UNITED STATES
DEPARTMENT OF THE INTERIOR
BUREAU OF LAND MANAGEMENT
APPLICATION FOR PERMIT TO DRILL OR REENTER

1a. Type of work: <input checked="" type="checkbox"/> DRILL <input type="checkbox"/> REENTER 1b. Type of Well: <input checked="" type="checkbox"/> Oil Well <input type="checkbox"/> Gas Well <input type="checkbox"/> Other 1c. Type of Completion: <input type="checkbox"/> Hydraulic Fracturing <input checked="" type="checkbox"/> Single Zone <input type="checkbox"/> Multiple Zone		5. Lease Serial No. NMNM102917 6. If Indian, Allottee or Tribe Name 7. If Unit or CA Agreement, Name and No. 8. Lease Name and Well No. CASEY JONES 21 FED COM 727H

APPROVED WITH CONDITIONS

Design B**4. CASING PROGRAM**

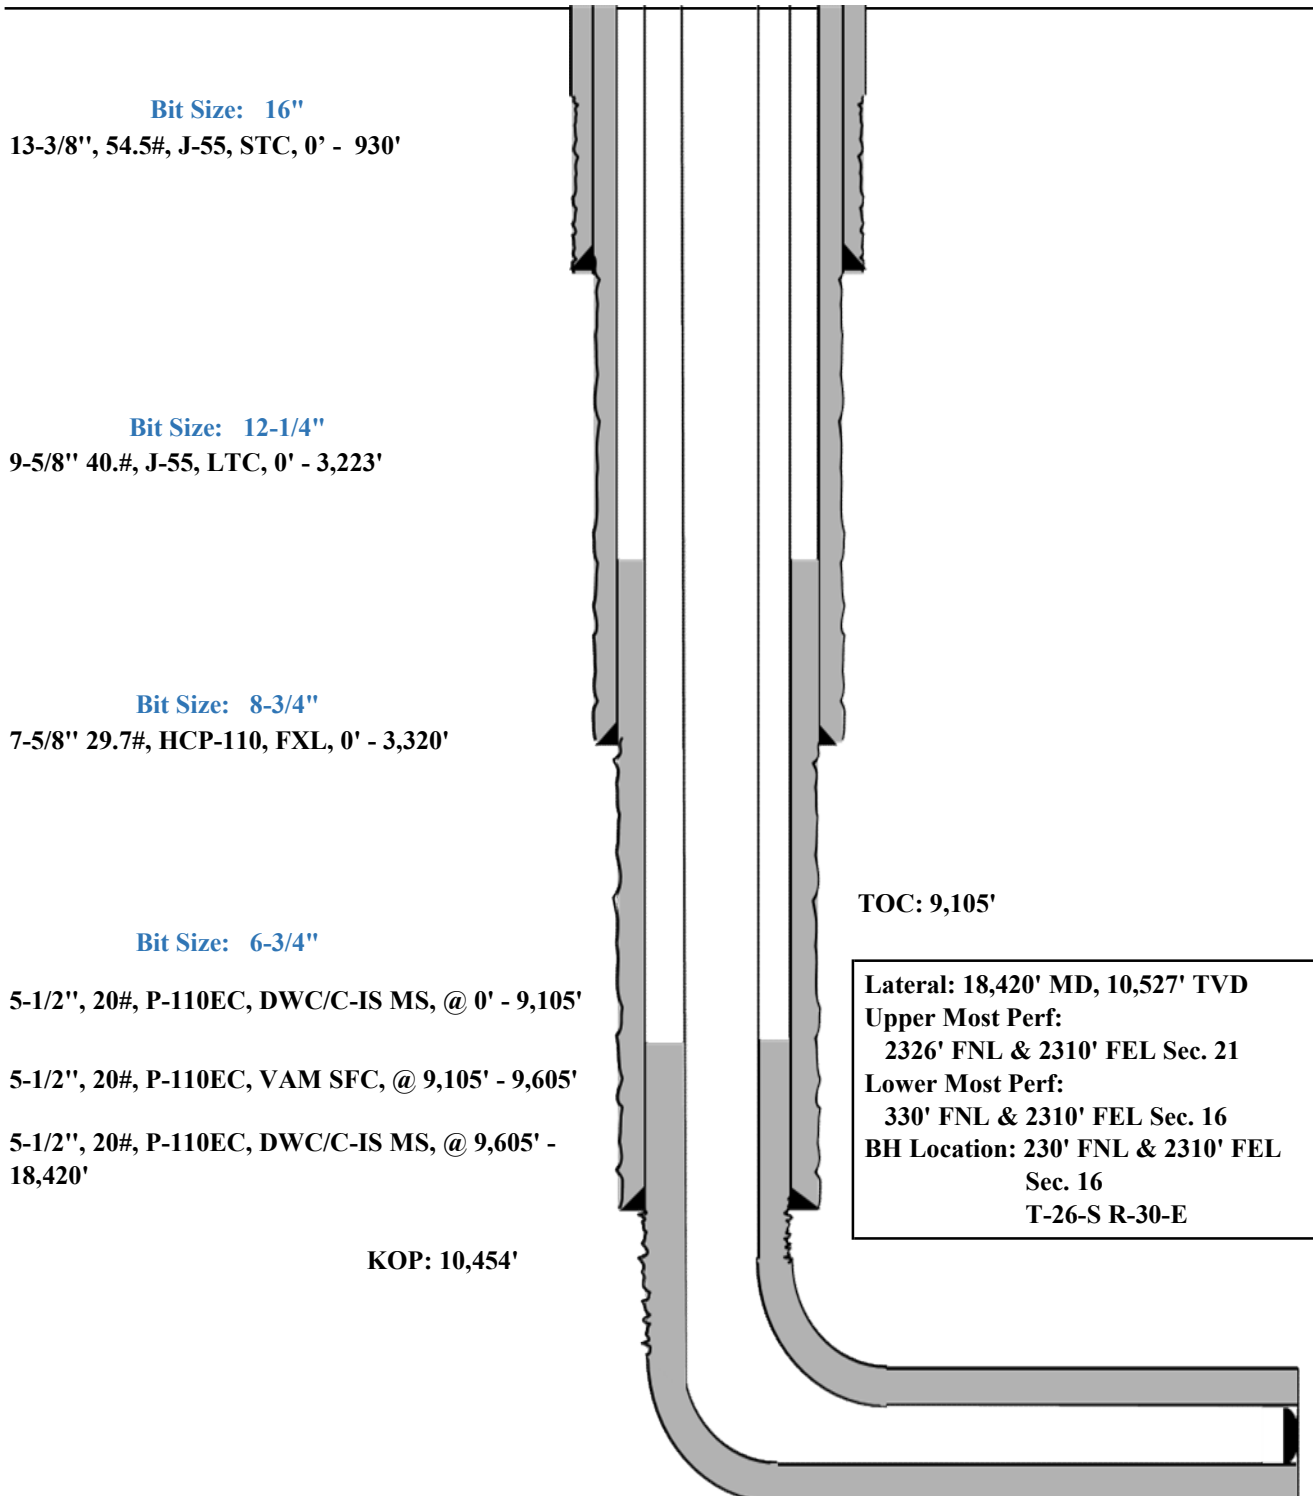
Operator is only approved for Design A. Design B is not to be utilized. If Design B is needed or any other change, please submit a NOI sundry to make the changes.
